SUBJECT: NuScale Power, LLC Response to NRC Request for Additional Information No. 28 (eRAI No. 8771) on the NuScale Design Certification Application

NuScale Response to NRC Request for Additional Information eRAI No. 8771

15.0.06 Return to Power

Figure 15.0-10: Return to Power - Net Reactivity (Peak Power Case)

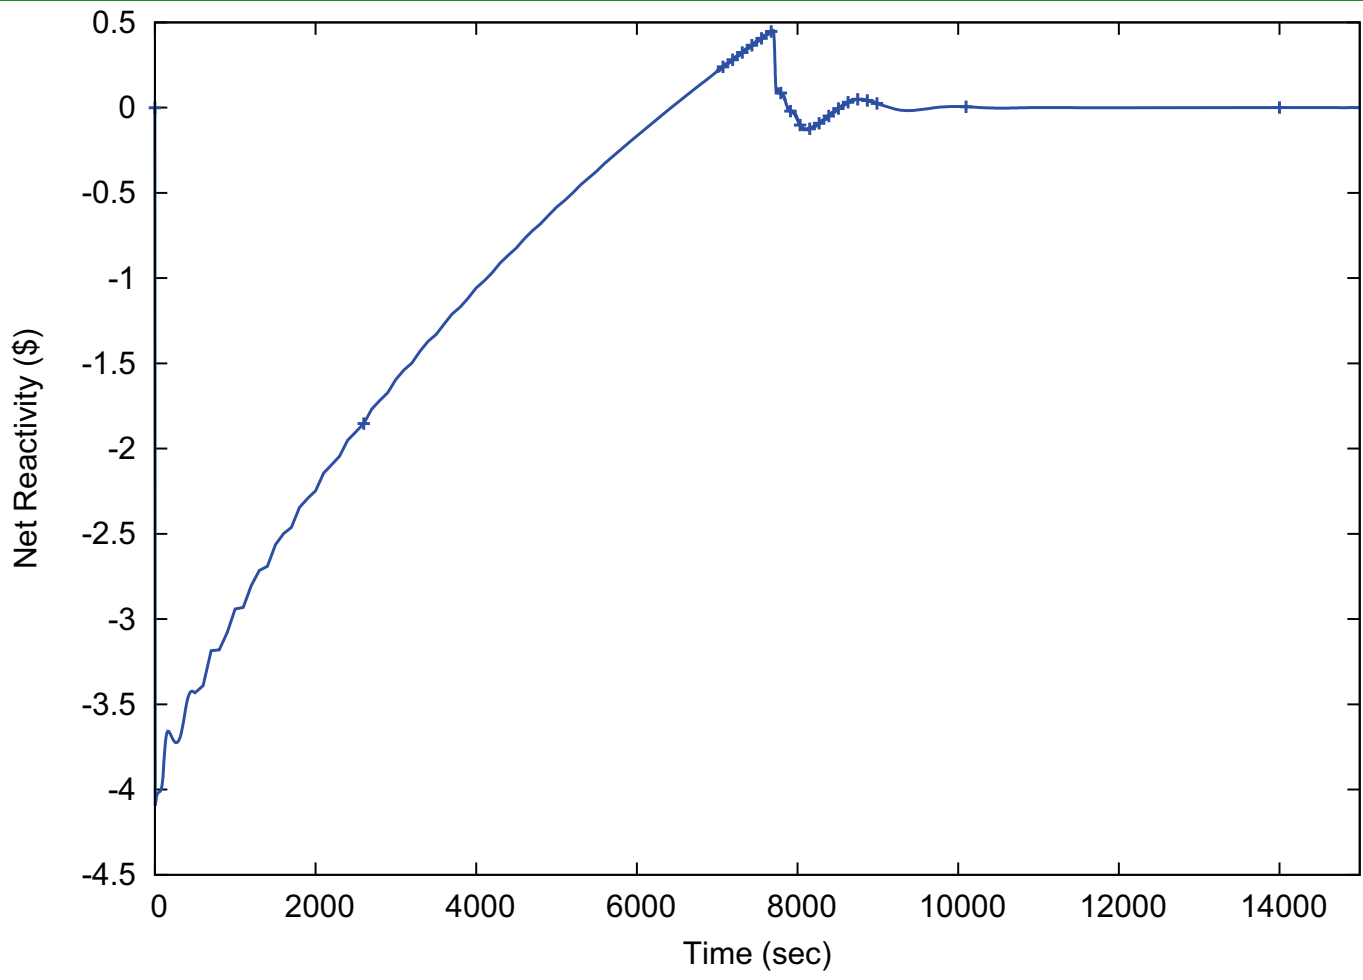
Based on the detail provided in Section 15.0.06, the staff is unable to reach a reasonable assurance finding that the SAFDLs will not be exceeded. The staff is requesting that Final Safety Analysis Report (FSAR) Section 15.0.06, which assumes the use of the decay heat removal system (DHRS), be modified to include details provided for a licensing basis event, and the short term transient analyses in the various subsections of Chapter 15 should reference Section 15.0.06 for the potential long term acceptability of the events. Additional information should include, but not be limited to, a description of the evaluation model(s); the critical heat flux (CHF) correlation used and basis for the correlation (or a reference there to); the assumed radial and axial power distributions and the basis for those power distributions (or a reference there to); and a justification of how reactor stability is maintained under these conditions such that the MCHF can be accurately determined. In addition to Figure 15.0-8, "Power Response on a Return to Power," the staff is requesting the FSAR be updated to include plots of reactor coolant system average temperature, pressurizer pressure, core reactivity, hot channel nuclear enthalpy rise factor (F-delta-H), and MCHF ratio verses time.

The overcooling return to power event begins with an initial negative reactivity insertion that is gradually removed as the transient progresses until a return to power occurs (Figure 15.0-8 and Figure 15.0-10). The biased initial conditions, with increased heat transfer, and low pool temperature results in a slightly larger return to power. A sensitivity analysis on background decay heat shows a minor sensitivity, where higher decay heat results in a slightly slower event progression and marginally decreased peak power. Initial negative reactivity insertion also has little impact on the calculated peak power. Therefore, it is concluded that protection of shutdown margin is insignificant for this event.

The return to power (Figure 15.0-8 and Figure 15.0-10) occurs more than two hours from the start of the transient, meaning the initiating event has little impact on the event progression and results. These cases are initiated from HZP conditions, which subsumes initiation events from hot full power (HFP) conditions due to the nature
